Public comment response

Re: Project File #608020 Cape Cod Bridges Project

However, the current design for the multimodal facility on the Bourne South Quadrant presents significant unaddressed impacts to the human and natural environment. This comment highlights the issues and proposes a design modification, and requests a preliminary design & cost estimate (capital & operating) for it.

Figure 2 - Location of proposed overpass versus existing path plan

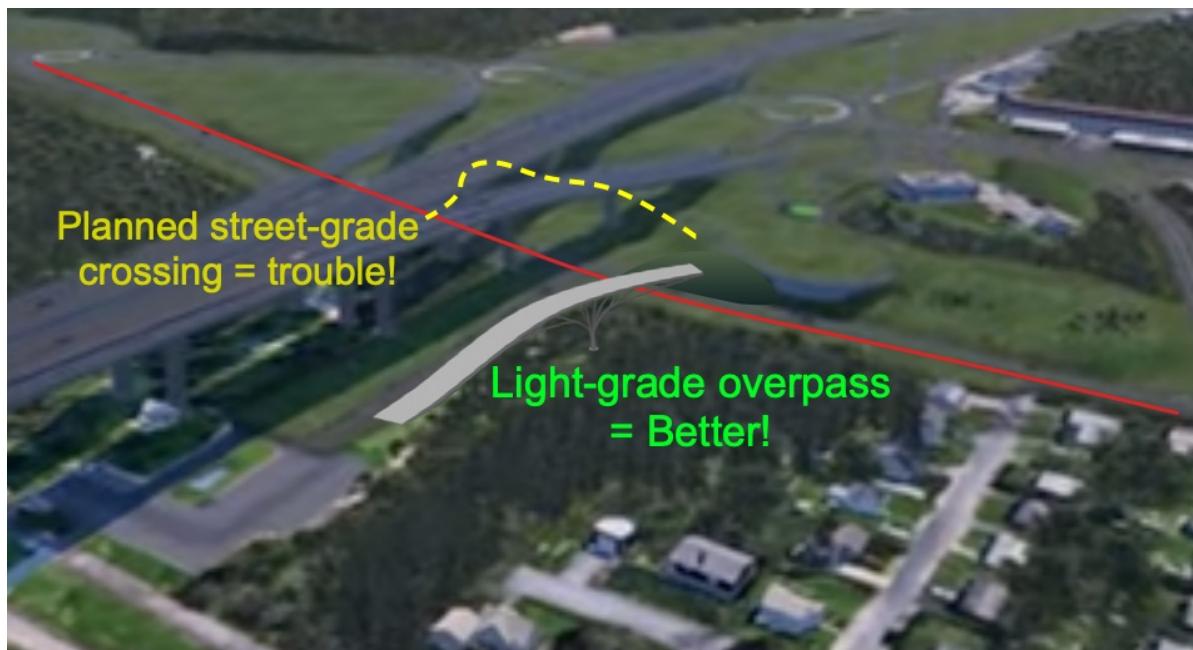
A light, ramped, grade-separated bike & walker overpass is a simple cost-effective solution that **eliminates the problems entirely**. An overpass can leverage existing site elevation and the already-planned retaining wall to descend towards the canal into the Bourne Recreational Area. Figure 2 illustrates this.²

This overpass constitutes a reasonable design alternative that meets the project's purpose and need while reducing adverse effects on both the human and natural environment. The benefits are clear:

Figure 3 - Descent grade eliminated

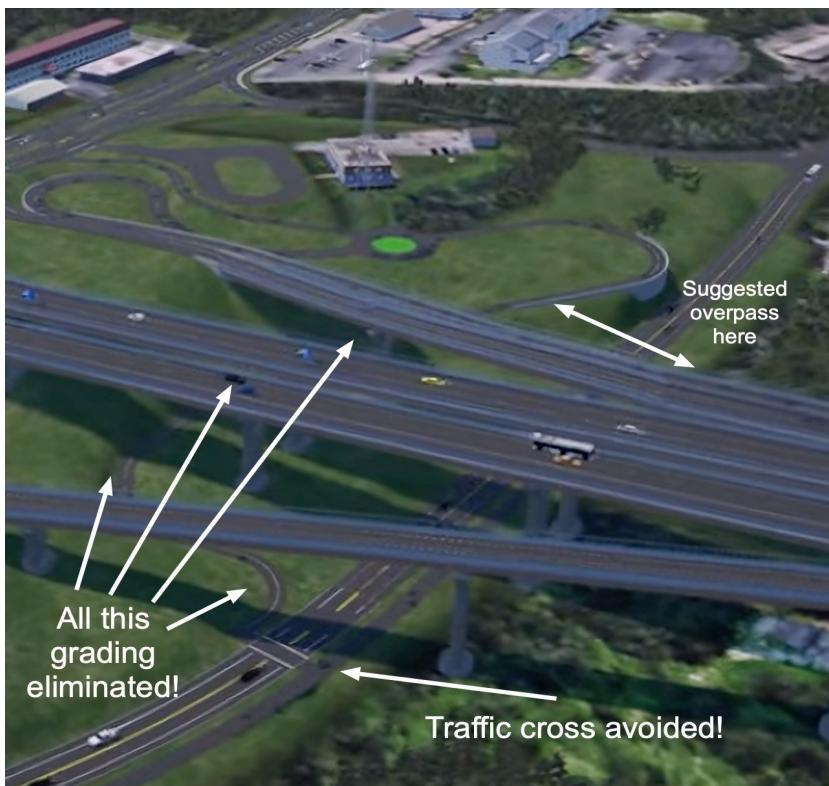
- **Improves safety unequivocally.** The overpass entirely removes the interaction between bikes, walkers and drivers.
- **Further encourages usage.** Eliminating fear of car collisions makes all users happier, resulting in increased year-round use by locals and visitors.
- **Better supports event surges.** Large-scale events can proceed without closing the road or requiring law enforcement control. Smaller events will be feasible because hiring police traffic control will not be needed.
- **Simplifies canal bike path connection.** The overpass can safely exit near most users' destination - the bike path.
- **Improves site impact.** Utilizing existing right-of-way maintains land alignment, leverages the descending elevation, and eliminates extra berms and erosion control.

Figure 4 - Descent Ramp into Bourne Recreation Area

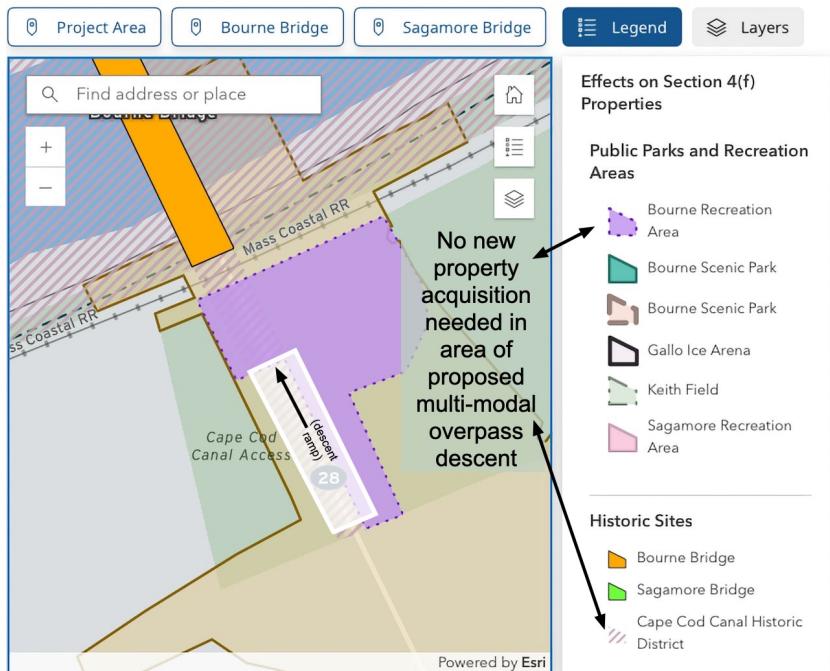
- **The change leverages planned structures.** A structural berm and major path descent are already included in the current plan; these elements can be reworked to form the southerly approach to an overpass. The actual overpass can be a light, non-vehicular structure.
- **No new property required.** The northern side of the overpass, which constitutes the descent over grade, can descend into the

existing Bourne Recreation Area and Cape Cod Canal District property. No property taking is required. See rough placement illustrated in Figures 3 & 4.
